AMENDMENTS TO THE DRAWINGS:

Serial No. 09/469,307
Reply to Office Action dated April 12, 2005

Docket No. P-0056

FIG. 2

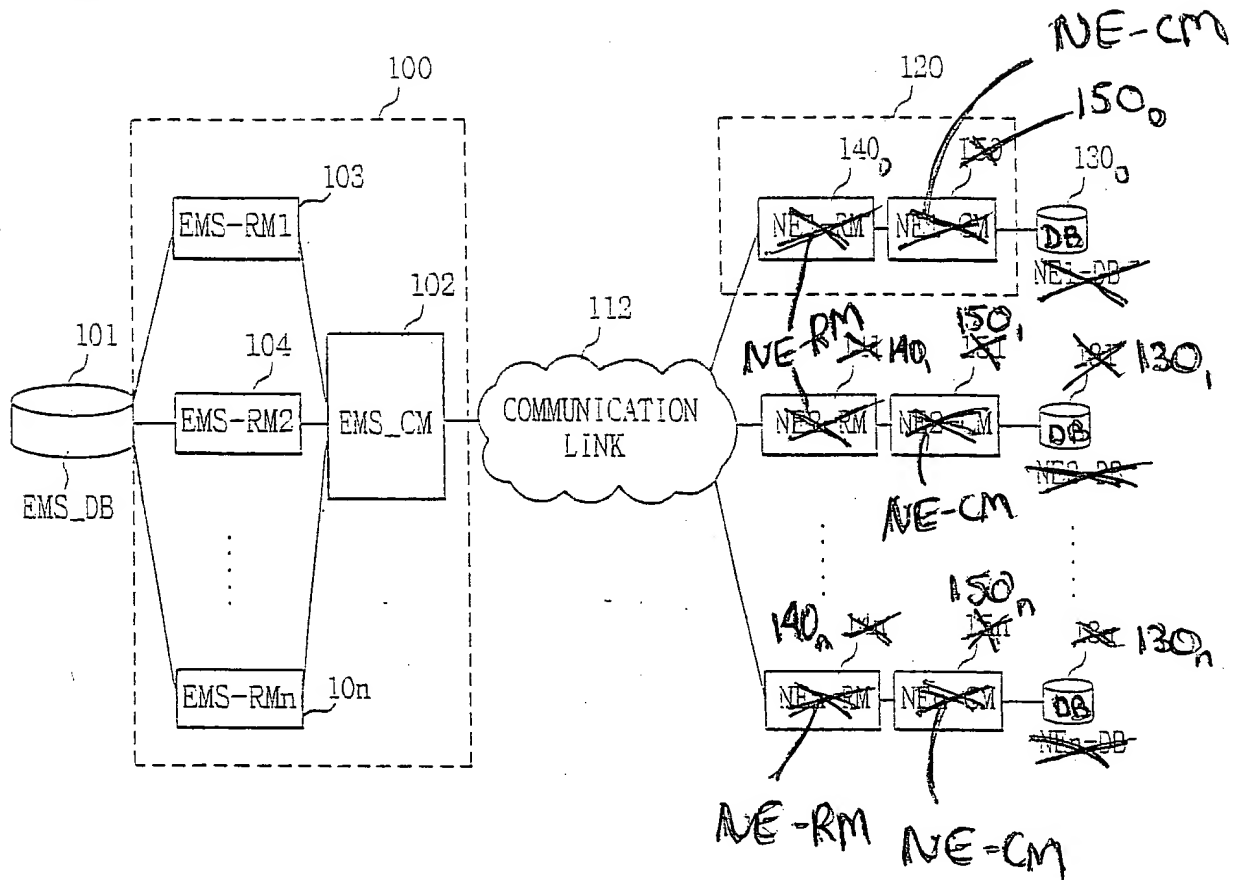
The attached drawings include changes to Figs. 2, 3, 4 and 5 . These sheets, which include Figs. 2, 3, 4 and 5, replace the original sheets including Figs. 2, 3, 4 and 5. The amendments to Fig. 2 are to show subscripts of various elements (as requested in the Office Action). The specification is also amended accordingly. Further, Figs. 4 and 5 are amended to correct typographical errors.

On page 4, lines 7-11, the Office Action appears to state that subscripts should be provided with respect to each of the components. However, Fig. 2 shows elements NE₁, NE₂...NE_n in which the "n" may be considered as a subscript. Additionally, the description

with regard to Fig. 4 clearly relates to a NE_i transmitting data to the EMS. One skilled in the art would clearly understand that the description is with regard to an NE component and that these operations may be performed for various NE components. However, in an effort to further prosecution, applicant has amended the specification on page 5 to add subscripts to NE components such as NE_DB 130₀...130_n, NE_CM 150₀...150_n and NE_RM 140₀...140_n. Fig. 2 is similarly amended. No new matter is added.
